COMMENT RESPONSE DOCUMENT

EASA PAD No. 16-042

[Published on 18 February 2016 and officially closed for comments on 15 April 2016]

EASA Part-M regulation extract

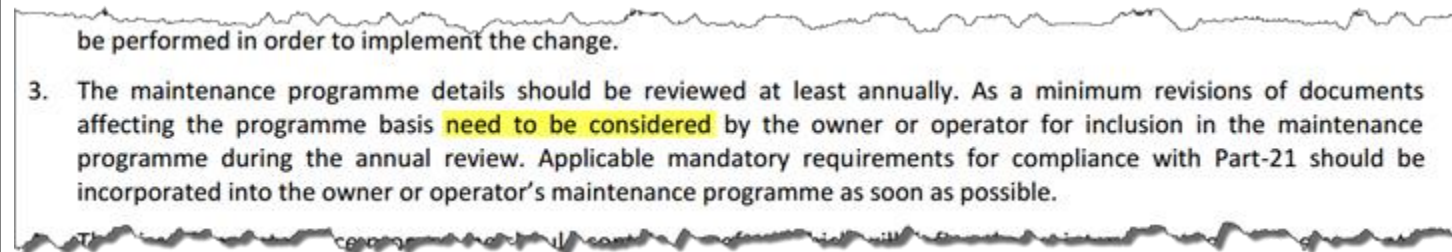
a) As this '12 Month' implementation limit is not defined within any of the ALS documents, EIN assumes this new requirement was added (by Airbus / the EASA?) due to consideration of PART-M, M.A.302;

Point 2 a) Comment not agreed. The AD does not contain (references to) any actions or compliance times that are 'more penalising' than those in the ALS itself. The AD simply confirms that the actions described in the ALS are legally required and specifies when (12 months) those actions must be incorporated into the AMP. The update of the AMP is an 'administrative' task, unrelated to the compliance time(s) for individual on-aircraft tasks.

PAD No 16-042 extract

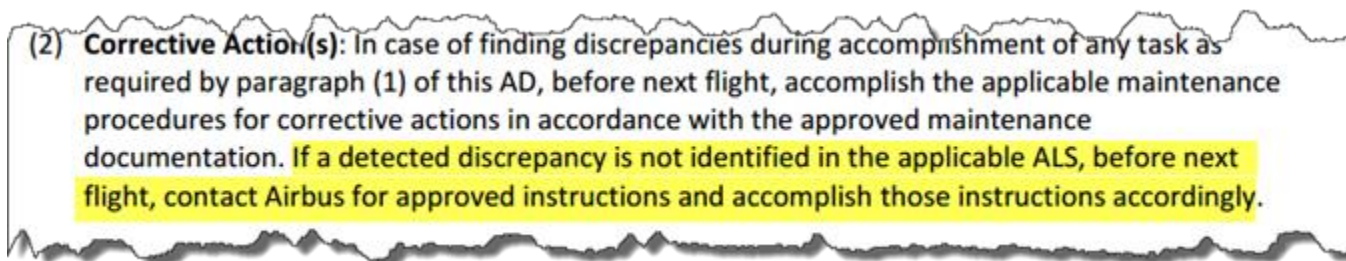
Point 1): Regarding Para (2) Corrective Action(s), highlighted sentence:

- a) “If a detected discrepancy is not identified in the applicable ALS,...” EIN believes a detected discrepancy would not be ‘identified’ in the applicable ALS (as the ALS only contains ‘reference(s)’ to inspection requirements / corrective actions). EIN suggests that this wording should state: “If *corrective action for a detected discrepancy is not identified in the applicable approved maintenance procedures, ALS*, before next flight, contact Airbus”

Point 1 a): Comment not agreed. See EASA answer to Comment # 3, Point 2) above.
